Re: Comments of Iberdrola Renewables, Inc. regarding the Tule Wind Project Draft DEIR/DEIS- Modified Project Layout

Tule Wind, LLC, a wholly owned subsidiary of Iberdrola Renewables, Inc. (IRI), submits this letter to summarize proposed minor modifications to the Tule Wind Project since the project was submitted to you with IRI's Applicant Environmental Document (AED) in September of 2010. Submitted herewith is a modified project layout in GIS format and other information, such as recently completed surveys and technical studies that have been revised based upon the Tule Wind Modified Project Layout. Enclosed with this letter are specific suggested edits to the Draft Environmental Impact Report/Environmental Impact Statement (EIR/EIS) in "track changes" format to help facilitate incorporation of the minor changes resulting from the Modified Project Layout into the Final EIR/EIS as the applicant's proposed project. IRI submits this information to the Lead Agencies to supplement IRI's comments on the Draft EIR/EIS for the Tule Wind Project submitted under separate cover.

Figure 1 - Modified Project Layout

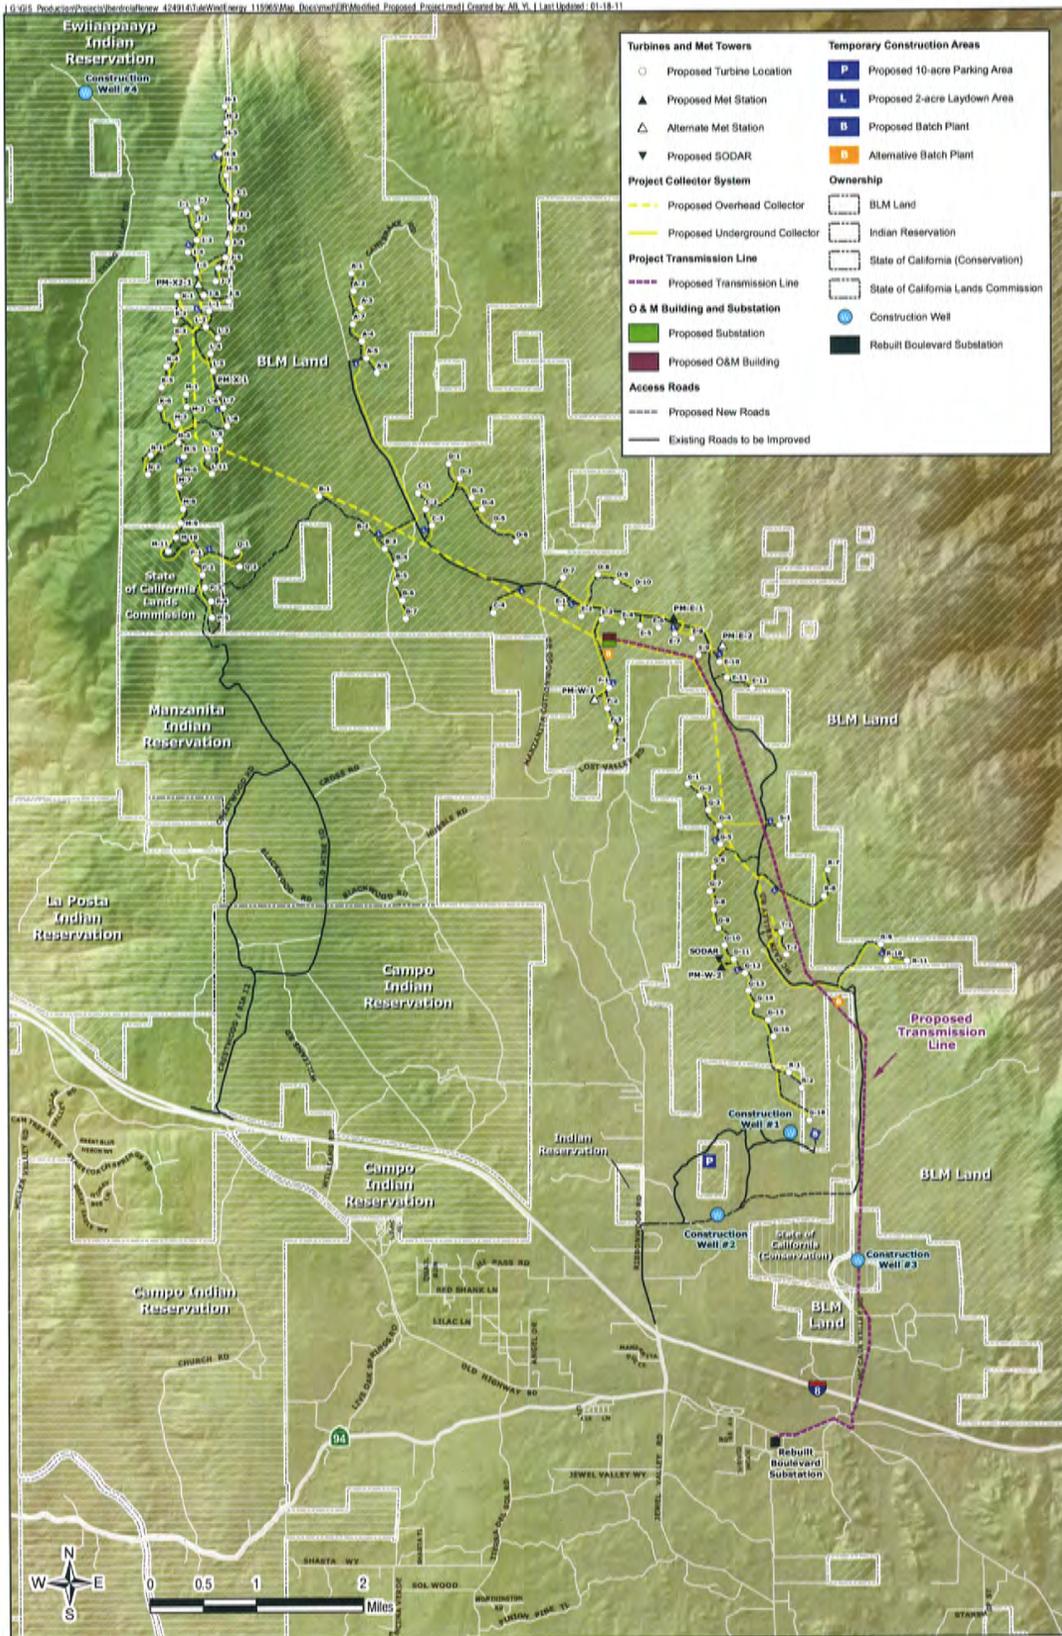
IRI is proposing minor modifications to portions of the Tule Wind Project facilities. Attachment A includes Figures 1 and 2 that graphically depict the modified project layout and the limited differences between the project layout analyzed in the Draft EIR/EIS and the modified project layout, respectively. The changes to the proposed project make minor adjustments to avoid resources and reduce the project's overall environmental impacts. Table A, *Key Project Components by Jurisdiction*, identifies the project modifications related to primary project features (turbines, transmission line, and access roads). Table B, *Project Components*, identifies a comparison of the change in impacts between all project

components. For example, the modified project layout proposes a maximum of 128 turbines, which is six (6) fewer turbines than were analyzed in the Draft EIR/EIS, and a resultant decrease of approximately 17 acres in permanent impacts. In addition, the modified project layout proposes a substantial reduction in the number of new access roads and improvements to existing roads compared to the project layout analyzed in the Draft EIR/EIS. As noted in Table B, the modified project layout reduces the number of improved new access roads from 114 to 75, and existing roads from 23 to 15 as opposed to 114 new roads and improvements to 23. This a reduction of 3.4 miles and 12.4 acres of permanent impacts as compared to the project layout analyzed in the Draft EIR/EIS. Other summary and project comparison (Draft EIR/EIS project layout vs. modified project layout) information attached includes: Table C – *Jurisdictional Areas*; and Table D – *Vegetation Communities*.

Figure 2 - Comparison - Draft EIR/EIS - Proposed Project and Modified Project Layout

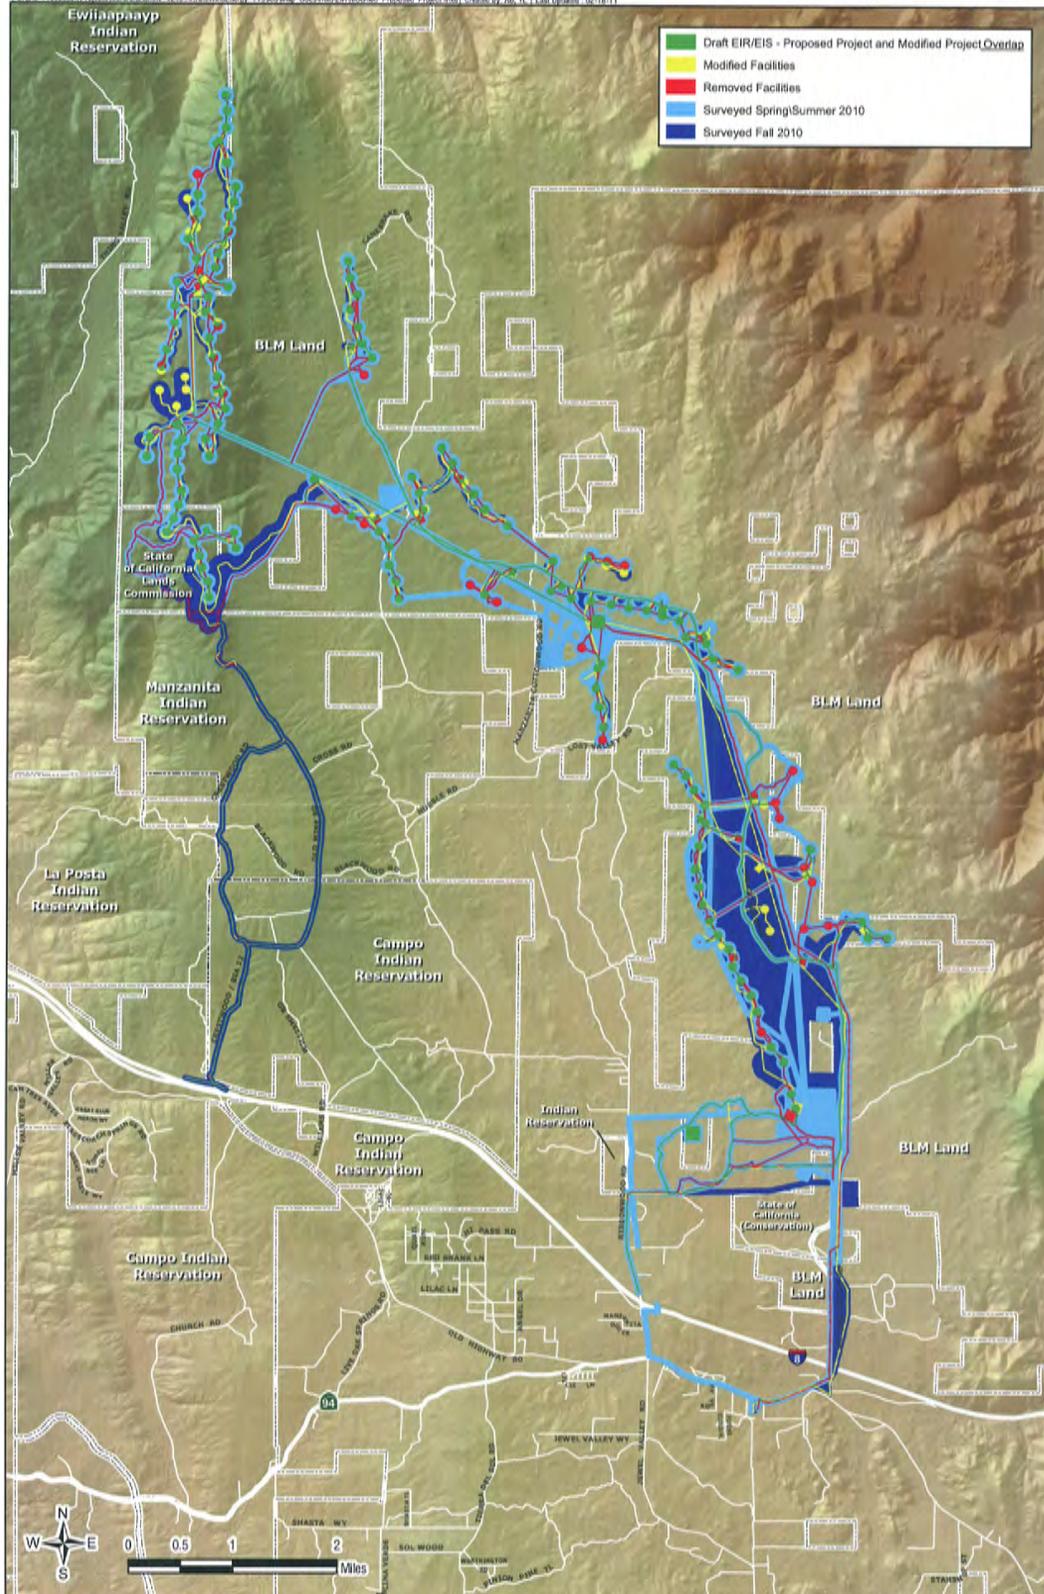
IRI conducted additional biological and cultural resources surveys on land where project modifications are located wherever they fell outside of areas previously studied. Figure 2 identifies the additional land area surveyed for cultural and biological resources. For each of the environmental issue area sections identified in the Draft EIR/EIS, analysis by our consultant HDR (as documented in the revised Draft EIR/EIS environmental issue areas sections) has determined that the modified project layout will result in similar or reduced impacts as compared to the project layout analyzed in the Draft EIR/EIS. Further, no new significant impacts justifying recirculation of the Draft EIR/EIS have been identified.

Figure A-1: February 2011 ECO Substation Design

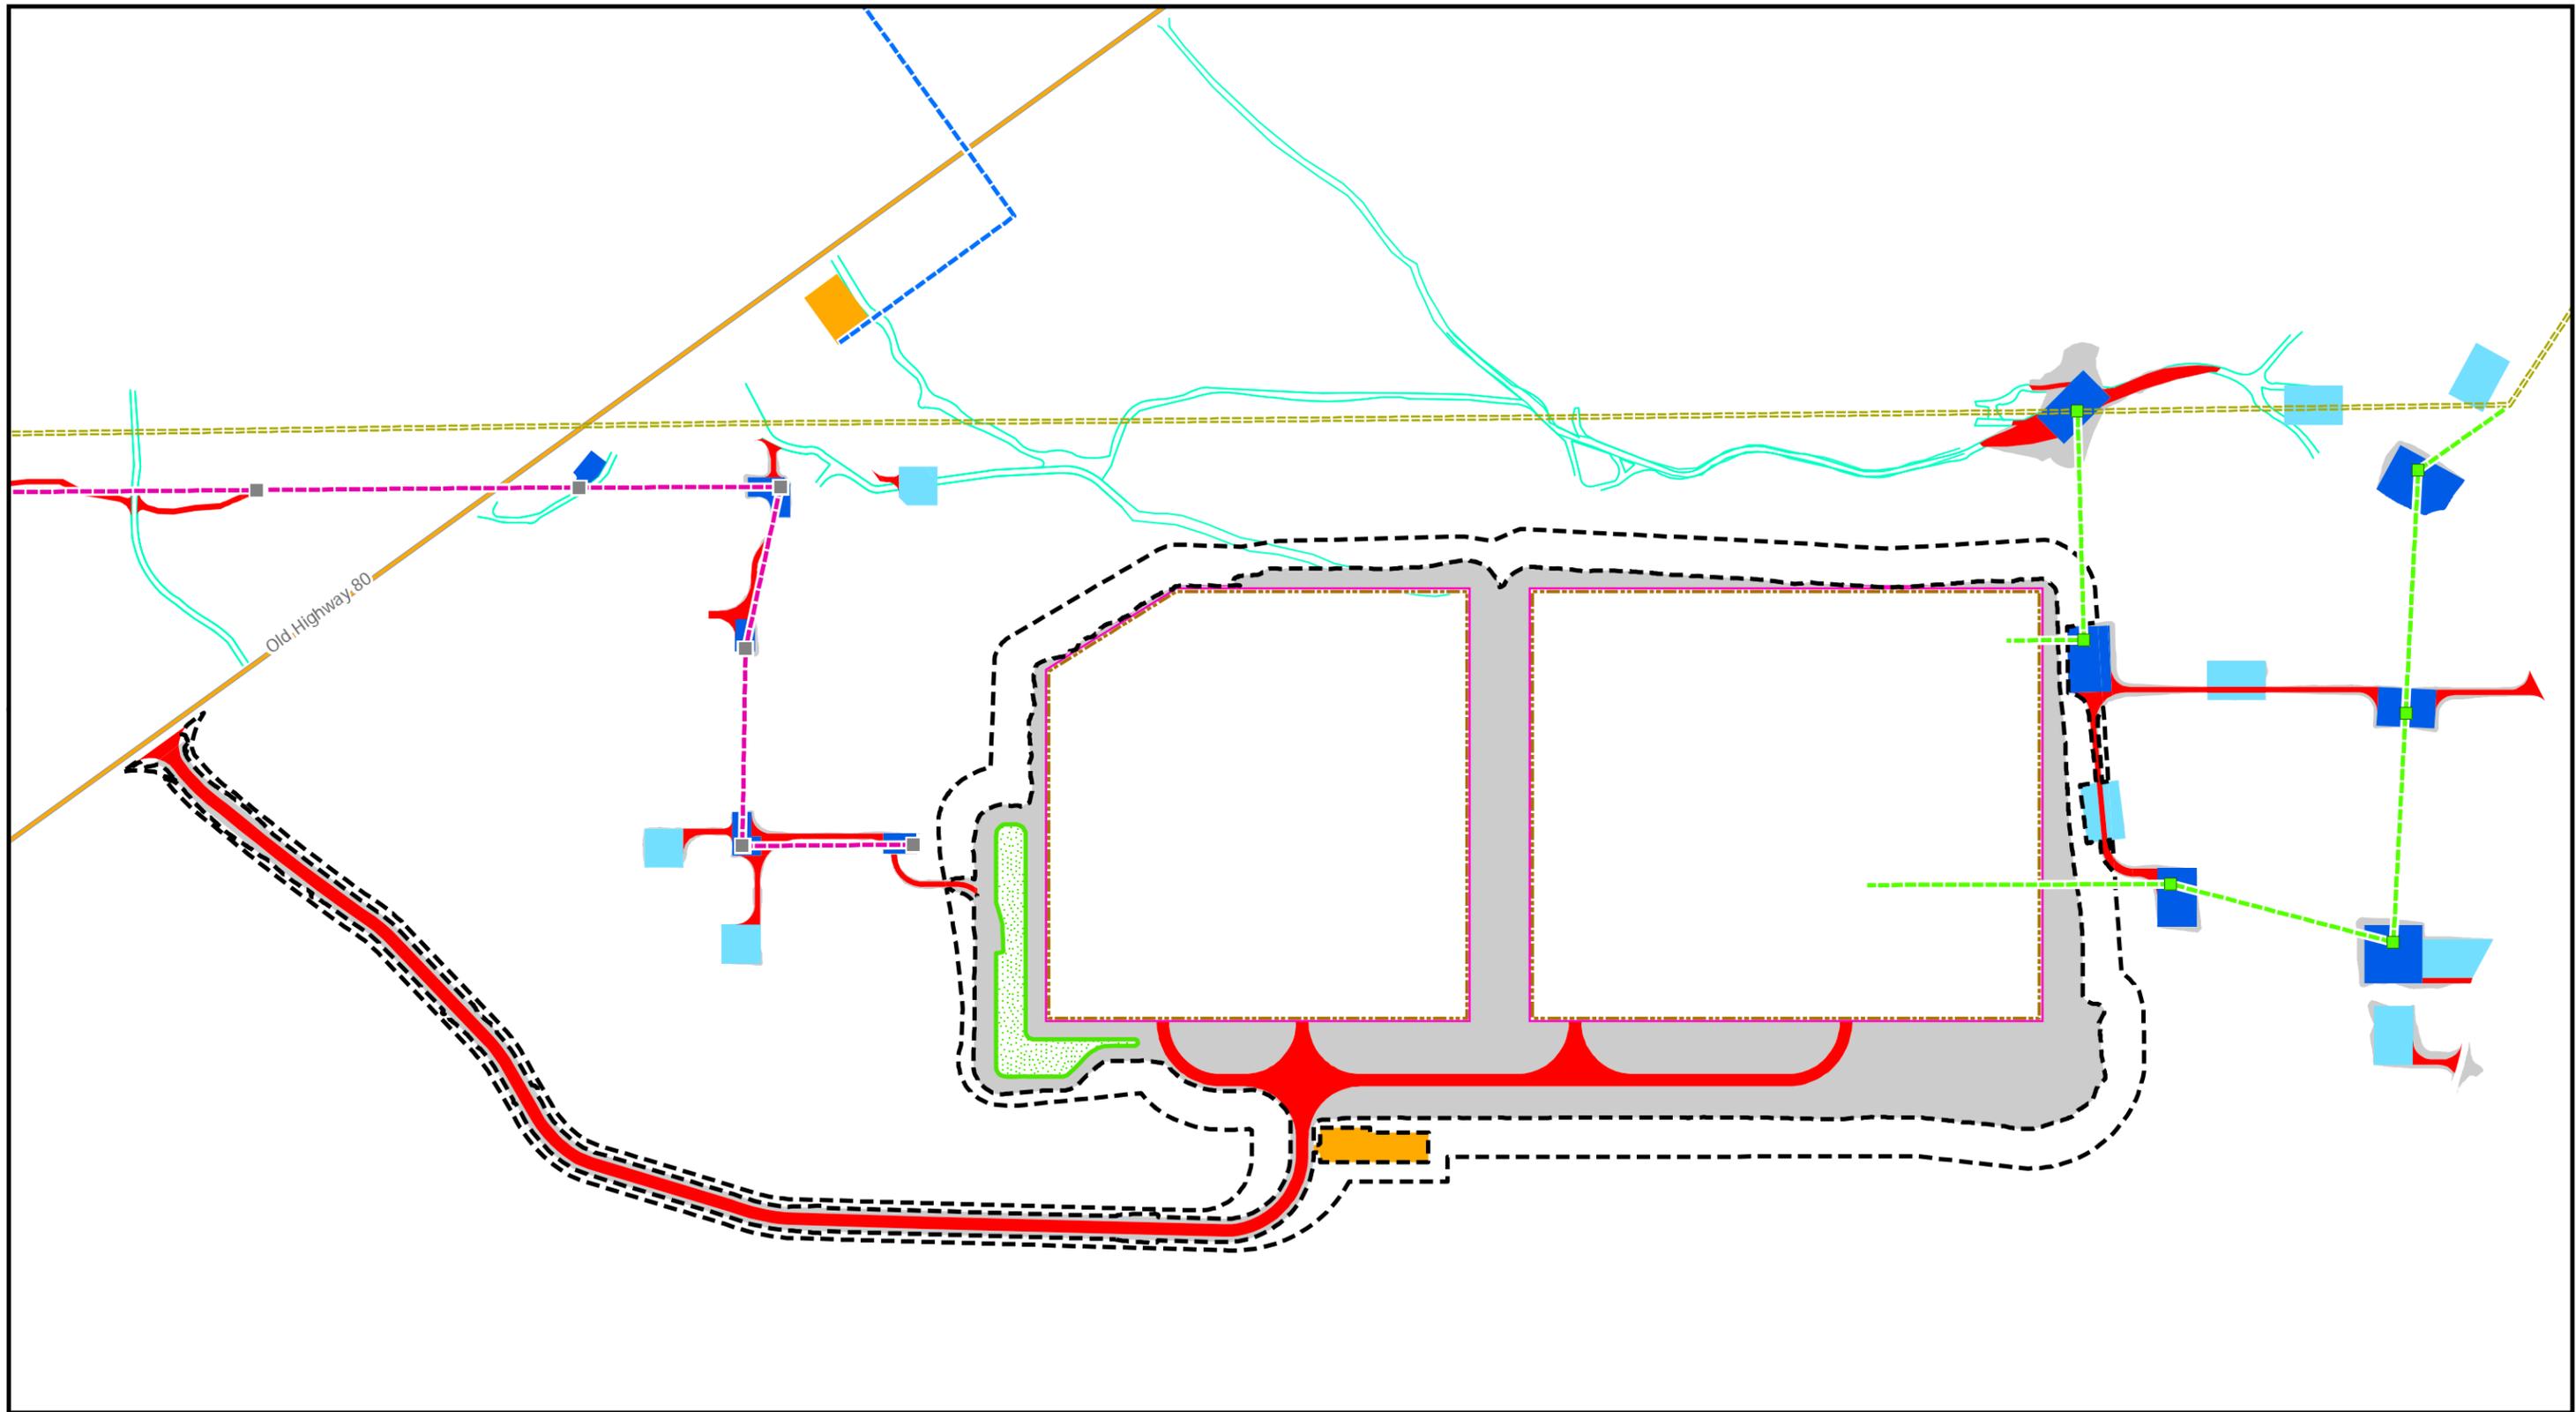
Slight modifications to the ECO Substation design were made in February 2011 for the ECO Substation Alternative Site, which is the preferred alternative location for the substation. These modifications include the addition of a staging yard north of the ECO Substation, as well as minor changes to the construction buffer and retention basin. The revisions are depicted in Figure A-1: February 2011 ECO Substation Design. New vegetation impact totals resulting from these revisions are reflected in Table A-5: Native Vegetation Community Impacts for the February 2011 Revisions, while impacts to drainages are shown in Table A-6: Jurisdictional Drainage Impacts.

Figure A-2: Boulevard Substation Rebuild Distribution Drawing

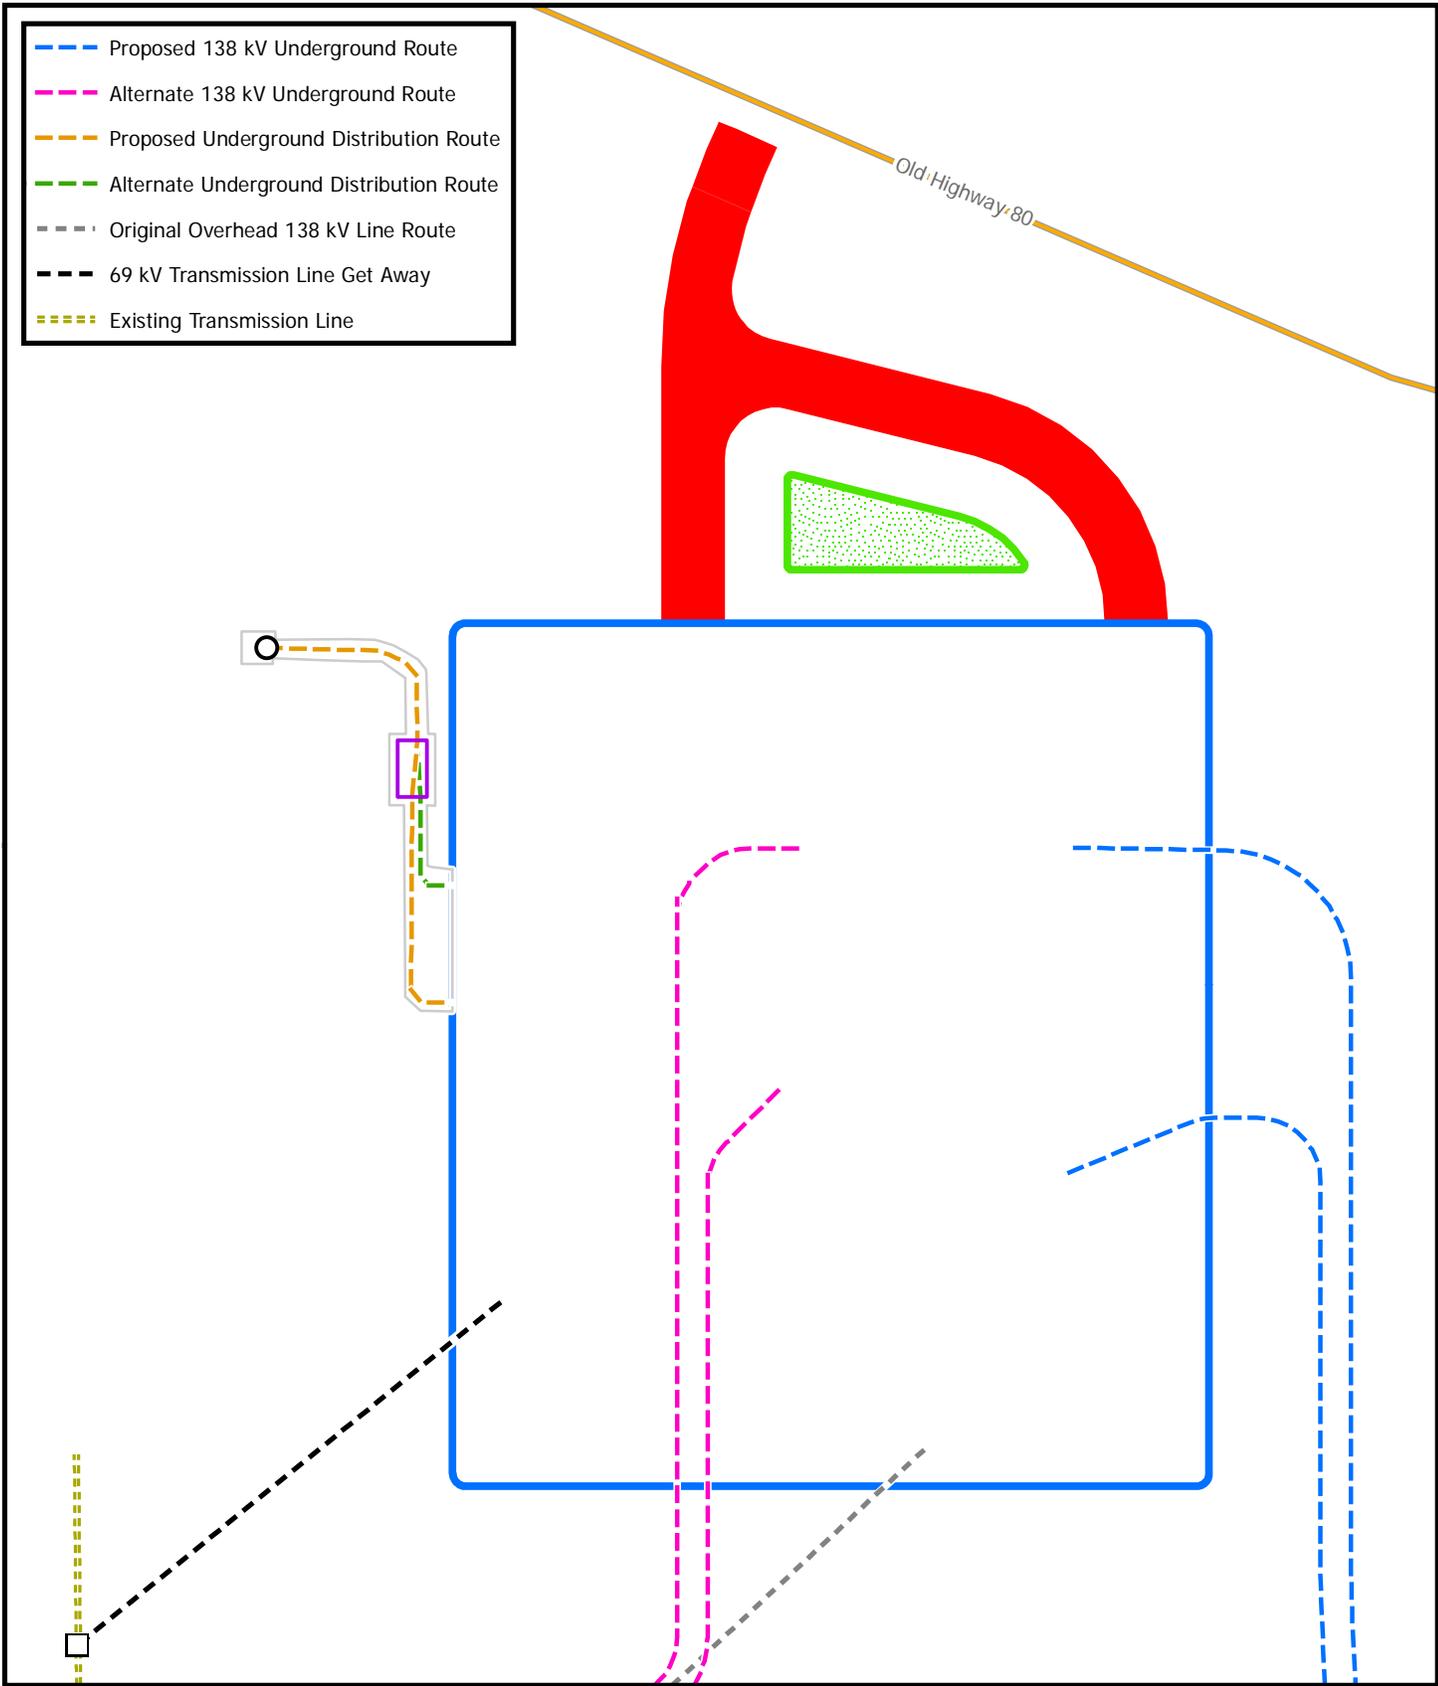
Rerouting of the distribution lines that currently enter and exit the existing Boulevard Substation will be required to connect the rebuilt Boulevard Substation to existing systems, as shown in Figure A-2: Boulevard Substation Rebuild Distribution Map. The proposed distribution reroute would exit the west side of the rebuilt Boulevard Substation through an underground duct bank carrying multiple distribution cables. At approximately 25 feet west of the existing fence line,

The alternative distribution reroute would travel in essentially the same alignment as the proposed reroute, but would exit the rebuilt Boulevard Substation at a location approximately 40 feet north of the proposed underground route. All other components for the alternative reroute would be the same as for the proposed distribution reroute. Therefore, the total area required for the alternative route would measure approximately 1,169 square feet. The proposed and alternative methods of rerouting the distribution lines to connect to the existing system are depicted in Figure A-2: Boulevard Substation Rebuild Distribution Map.
